TAFT KNOLLS III JSP19-34

Public hearing at the request of Trowbridge Land Development for Preliminary Site Plan, Site Condominium, Wetland Permit, Woodland Permit and Stormwater Management Plan Approval. The Subject Property is located in Section 22, South of Eleven Mile Road and East of Taft Road and is zoned R-4 (One Family Residential). The applicant is proposing to construct a 13-unit single-family residential development (Site Condominium) off of an extension of Danya's Way.

MOTION SHEET

PLANNING REVIEW

DRAWN MCS
DESIGNED MCS
APPROVED MCP
 P.E. JOB NO. 16-472
SCALE AS SHOWN
S5
 SITE PLAN

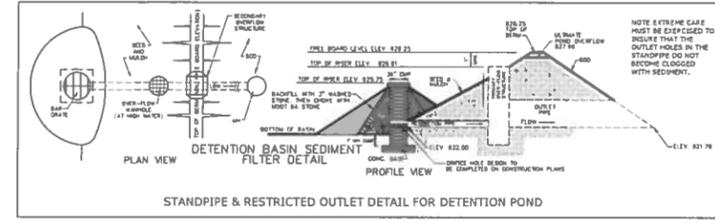
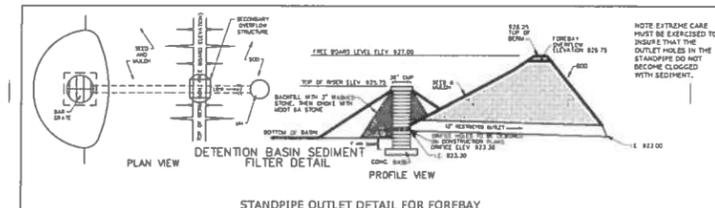
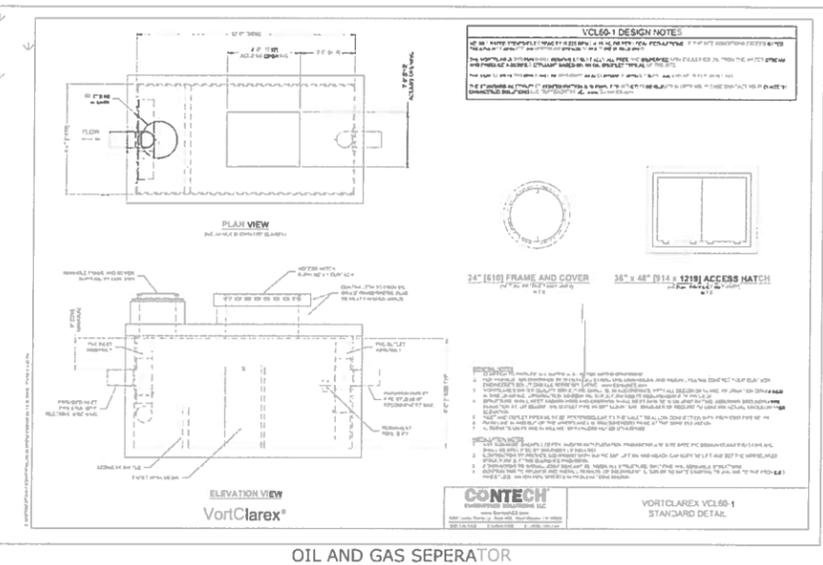
18. The Storm Water Management Plan for this development shall be designed in accordance with the Storm Water Ordinance and Chapter 5 of the new Engineering Design Manual.
19. Consider raising the forebay manhole to the same height as the detention basin high water line. There appears to be the potential that the two basins would achieve the same high water line since they are hydraulically connected.
20. Provide a soil boring report from a Geotechnical Engineer where the detention basin is proposed.
21. Indicate the size of orifice holes on the riser pipe on sheet S5.

| S4 | |

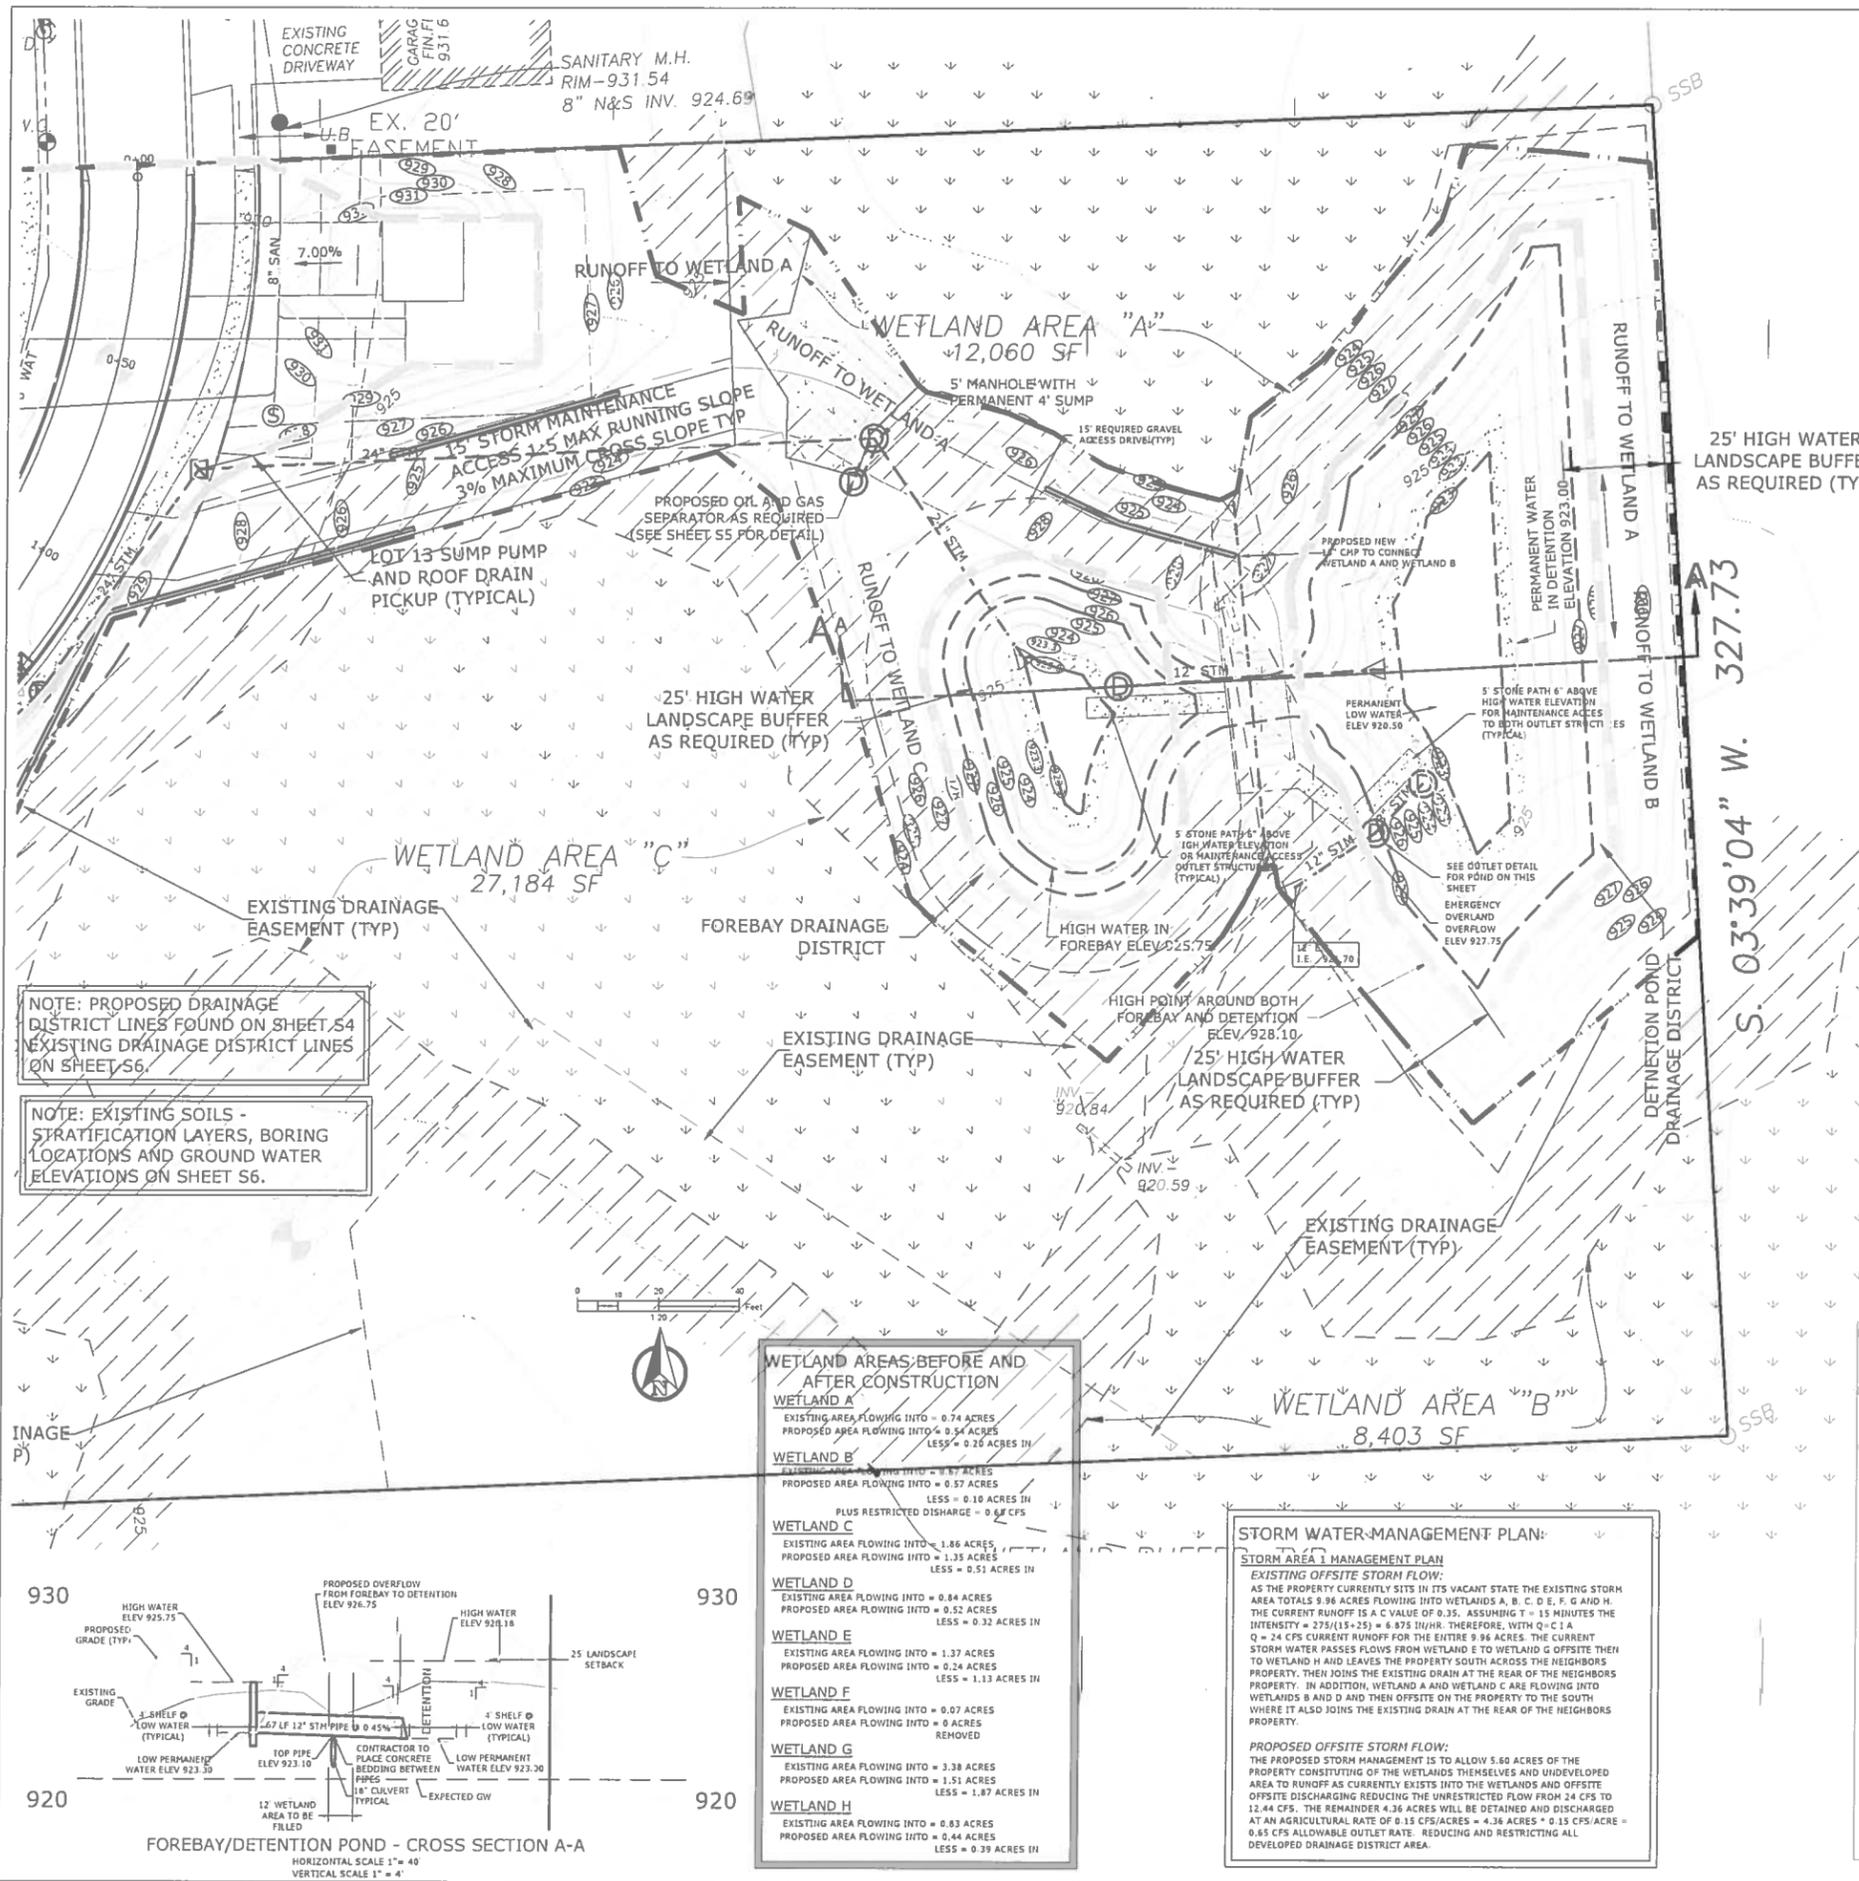
15. Provide a schedule listing the casting type and other relevant information (structure size, type, and rim/invert elevations) for each proposed storm structure on the utility plan.
16. Note typical sump lead size and material on sheet S4.
17. Provide storm sewer profiles and illustrate all pipes intersecting storm structures.

TAFT KNOLLS III SITE CONDO DEMO AND WETLAND PLAN
 TAFT ROAD, CITY OF NOVI, MICHIGAN
ISSUE DATES
 CITY SITE PLAN 6/22/19
 CITY 10/31/2019
LEGEND
 DRAWN MCS
 DESIGNED MCS
 APPROVED MCP
 P.E. JOB No. 16-472
 SCALE AS SHOWN
S6
 SITE PLAN
 © 2019 Powell Engineering & Associates, LLC

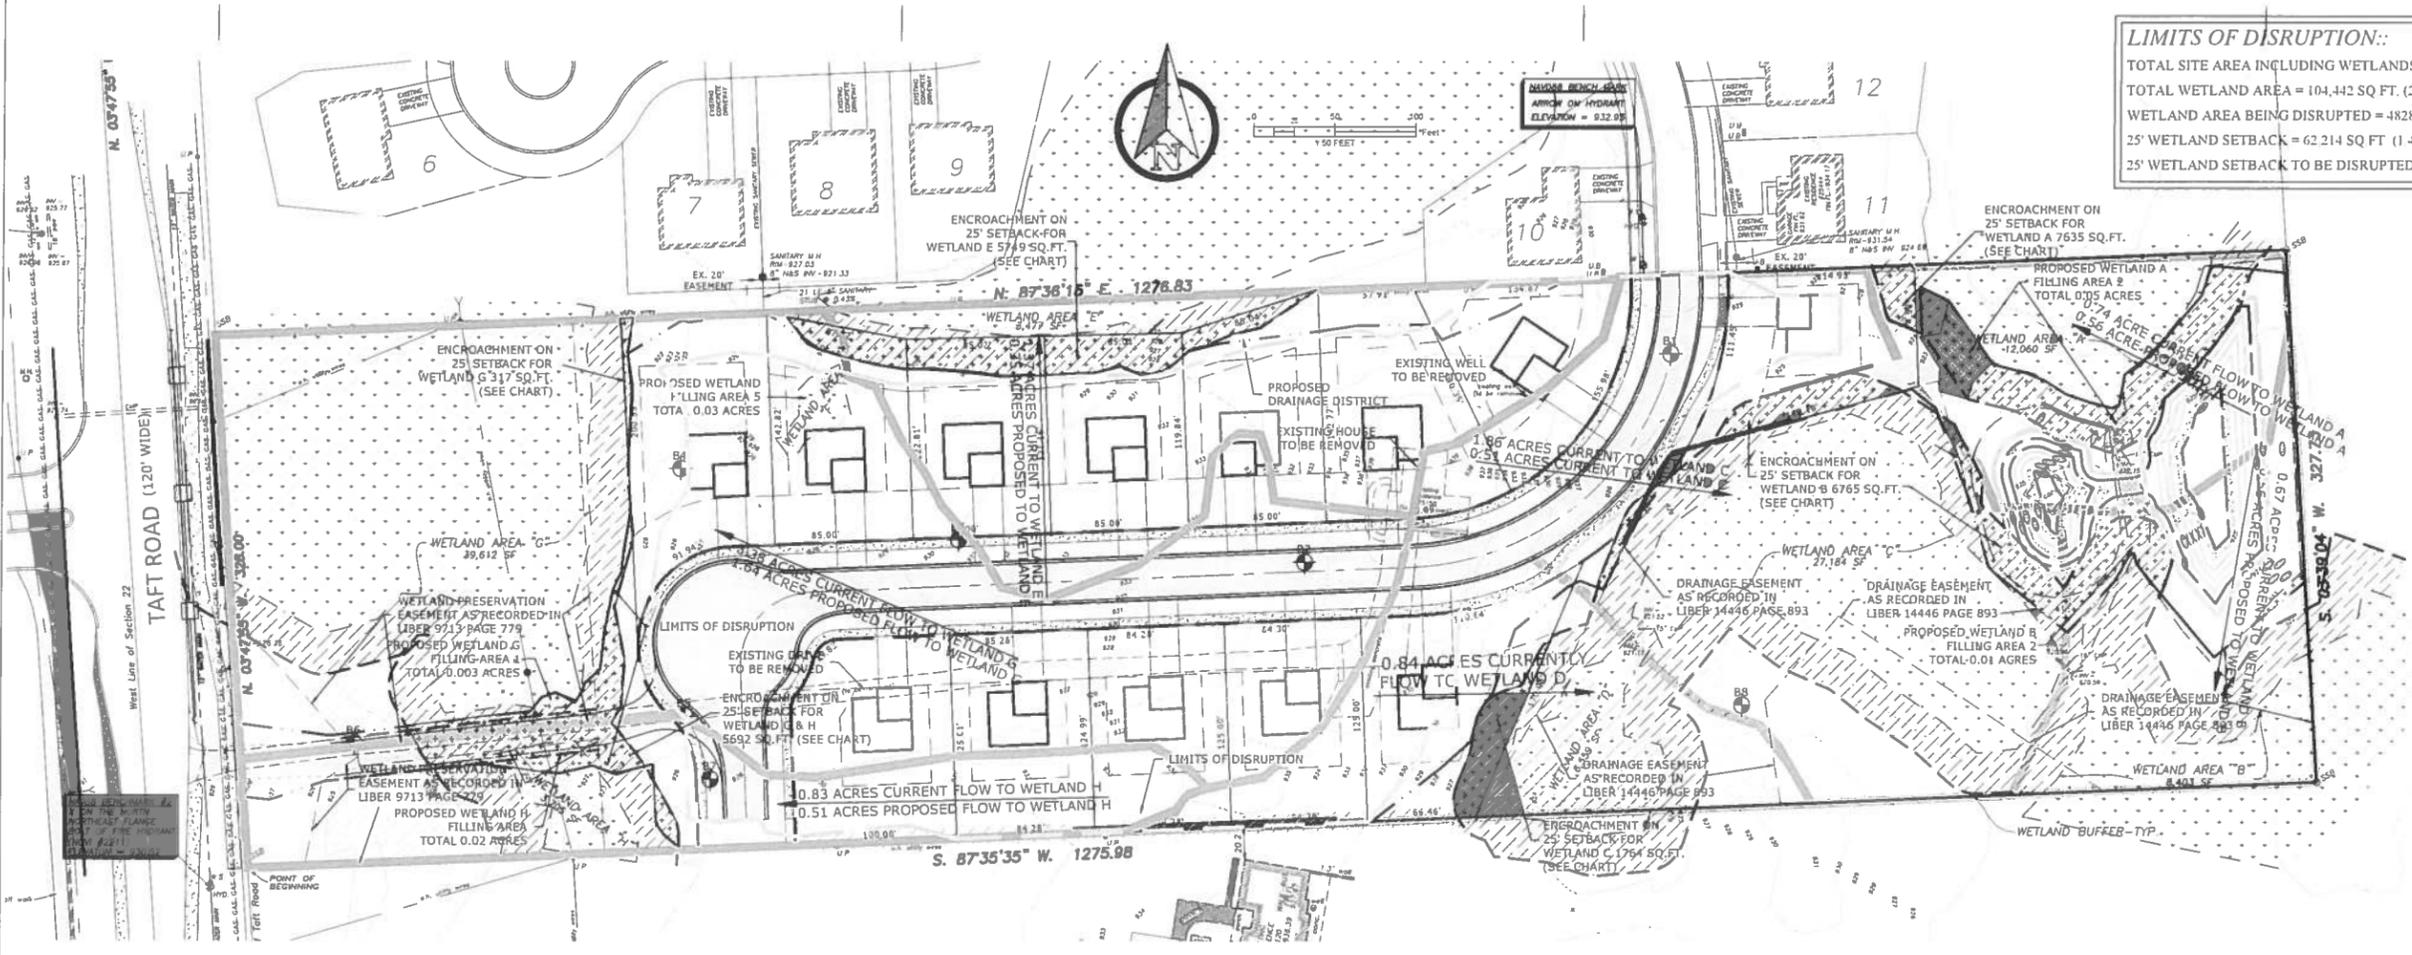
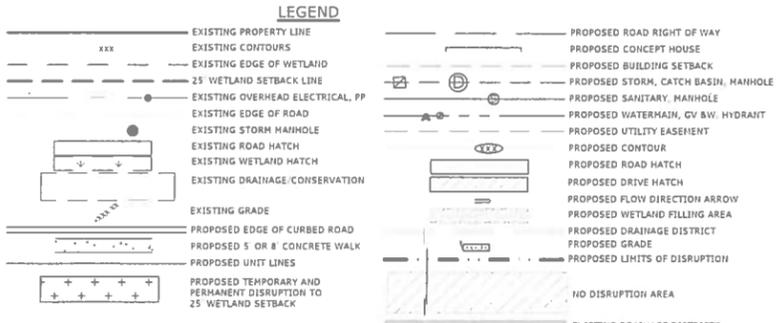
It should be noted that the impacts to the 25-foot setback of Wetland F has been omitted from the table and should be added to the Plan (*Demo and Wetland Plan*; Sheet 6) and the table. There are a few other

inconsistencies with regard to the information included on Sheet S6 (*Demo and Wetland Plan*). Please review and revise the following items on subsequent site plan submittals:

- The note/leader indicating setback impact to Wetland D incorrectly reads “encroachment on 25’ setback for Wetland C, 1,764 sq. ft.”;
- The note/leader indicating setback impact to Wetland A reads “encroachment on 25’ setback for Wetland A, 7,635 sq. ft.”. This impact area is not consistent with the table on Sheet S6. The Table indicates 6,900 sq. ft. of impact.

The *Temporary and Permanent Impacts to 25’ Wetland Setback* table on Sheet S6 indicates that the Wetland E 25-foot setback contained on Lots 3, 4, 5, and 6 will be deed restricted and signage will be placed every 50’ on-center along the wetland buffer boundary. This table should be updated to include similar information for Lot 12 (Wetland D) and Lot 13 (Wetland A). ECT recommends that in addition to the proposed signage, any proposed conservation easement areas should be demarcated on-site through other physical means such as boulders or decorative fencing along the setback boundaries.

1. Impacts to the 25-foot setback of Wetland F has been omitted from the Plan (*Demo and Wetland Plan*; Sheet 6) and the table. This information shall be added to the Plan.

2. There are a few inconsistencies with regard to the information included on Sheet S6 (*Demo and Wetland Plan*). Please review and revise the following items on subsequent site plan submittals:

- The note/leader indicating setback impact to Wetland D incorrectly reads “encroachment on 25’ setback for Wetland C, 1,764 sq. ft.”;
 - The note/leader indicating setback impact to Wetland A reads “encroachment on 25’ setback for Wetland A, 7,635 sq. ft.”. This impact area is not consistent with the table on Sheet S6. The Table indicates 6,900 sq. ft. of impact.

3. The *Temporary and Permanent Impacts to 25’ Wetland Setback* table on Sheet S6 indicates that the Wetland E 25-foot setback contained on Lots 3, 4, 5, and 6 will be deed restricted and signage will be placed every 50’ on-center along the wetland buffer boundary. This table should be updated to include similar information for Lot 12 (Wetland D) and Lot 13 (Wetland A). ECT recommends

PROJECT NUMBER
12170
SHEET NUMBER
C-4

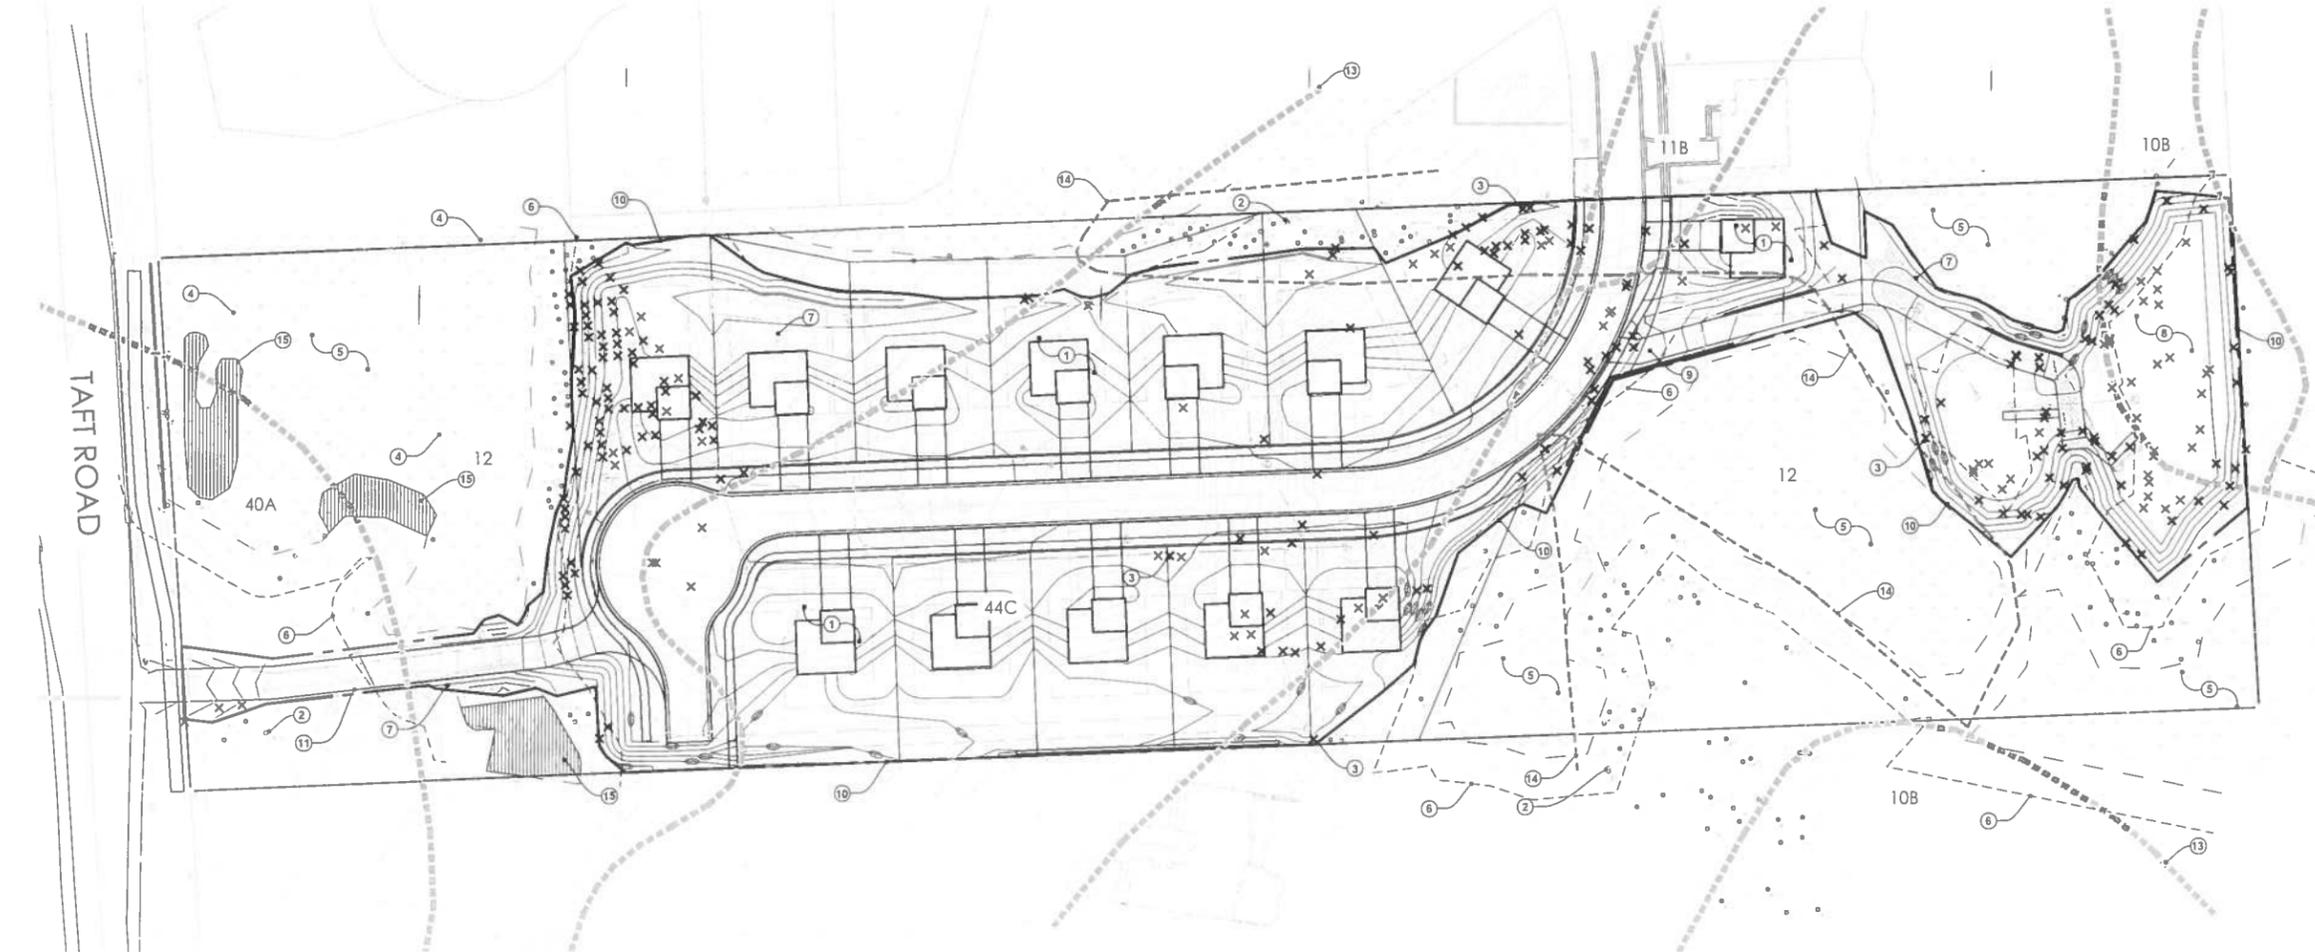
4. Please show the regulated woodland line from the city's map on Sheet C-4 and verify that trees to be saved, for which credits are taken, are not within the regulated woodland.
